SUNDRY NOTICES AND REPORTS ON WELLS
Do not use this form for proposals to drill or to re-enter an abandoned well. Use form 3160-3 (APD) for such proposals.

8. Well Name and No.
PEARSALL QN 10

Mack Energy Corporation Proposes to Plug well as follows:

****BLM REVISED ** BLM REVISED ** BLM REVISED ** BLM REVISED ** BLM REVISED ****

MACK ENERGY CORPORATION
PEARSALL QUEEN UNIT #10
Sec 5 T18S R32E 1980 FNL 1980 FEL

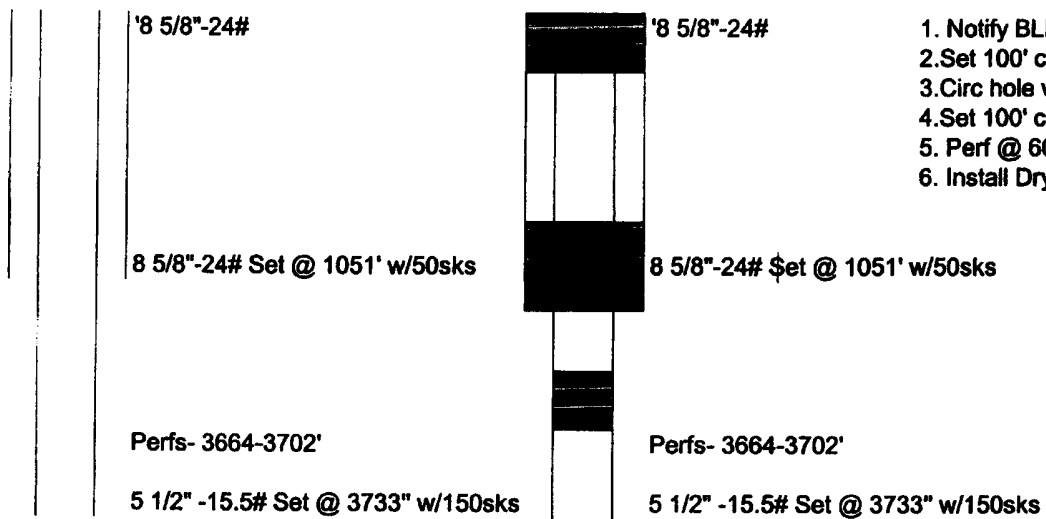
*Perforate 5 1/2" Casing @ 1280' & Squeeze W/ Sufficient Cement (40 SX) To Have
Solid Plug F/ 1280-1180' ~ TAG*
